**Sufficiency Gaps Identified in  
EPRI Report 3002025288 on  
Enhanced Risk-Informed Categorization  
Methodology for Pressure Boundary  
Components**

Office of Nuclear Reactor Regulation

April 30, 2024

# EXAMPLE 1

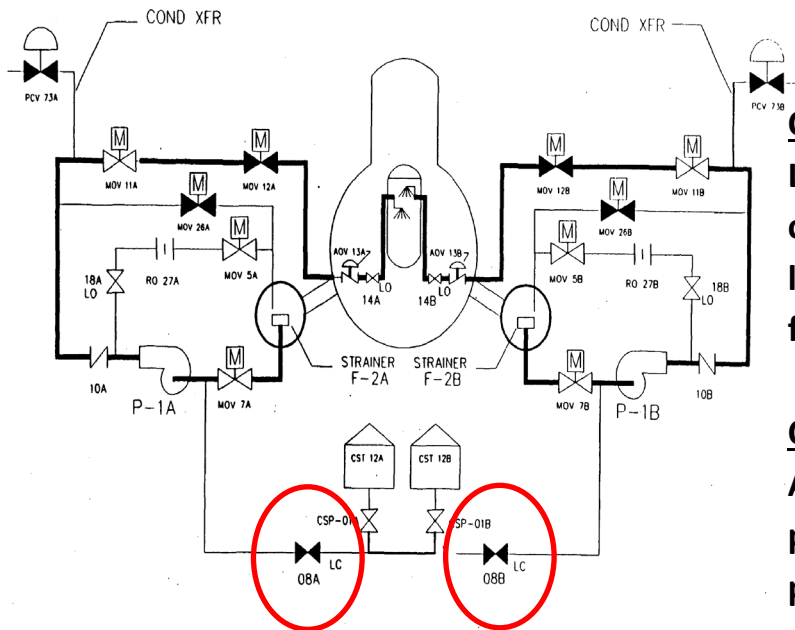
Low Pressure Core Spray system in a BWR/4 (Mark I containment). Piping to pump suction from each CST to locked-closed valves 08A and 08B located in the grade level floor of a Reactor Building Crescent area.

A single rupture of either line in each Crescent Area has the potential to result in flood and spray damage to a core spray pump, LPCI/RHR pump on one loop, and either HPCI or RCIC pump controls. The scenario may be high safety significant because it could erode several functional areas for core cooling.

This could be categorized as LSS since it falls outside the scope of Criterion 7 which only addresses failures associated with the CST for PWRs as HSS.

# EXAMPLE 2

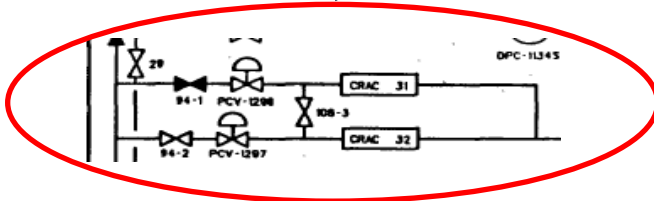
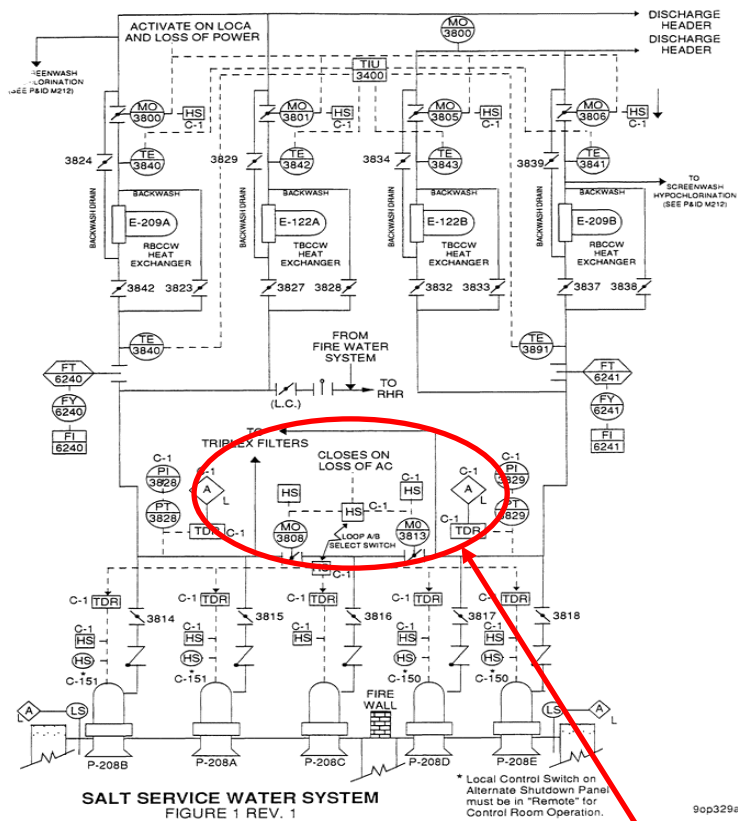
Common service water line in a 4-loop Westinghouse (pre-GDC) PWR from the Essential Header to both Control Room Air Conditioning (CRAC) unit condensers CRAC-31 and CRAC-32.

A single rupture could lead to loss of control room air conditioning since both CRAC units are impacted, and therefore pose a control room habitability issue in an accident scenario requiring isolation of the control room.

The staff is concerned that this would be categorized as LSS, per the EPRI proposed methodology, because the conditions of Criteria 1-10 may not be met. And, since control room HVAC is not modeled in most licensee model-of-records, there is no entry into Criteria 11-13 as a safety-net to determine as HSS.
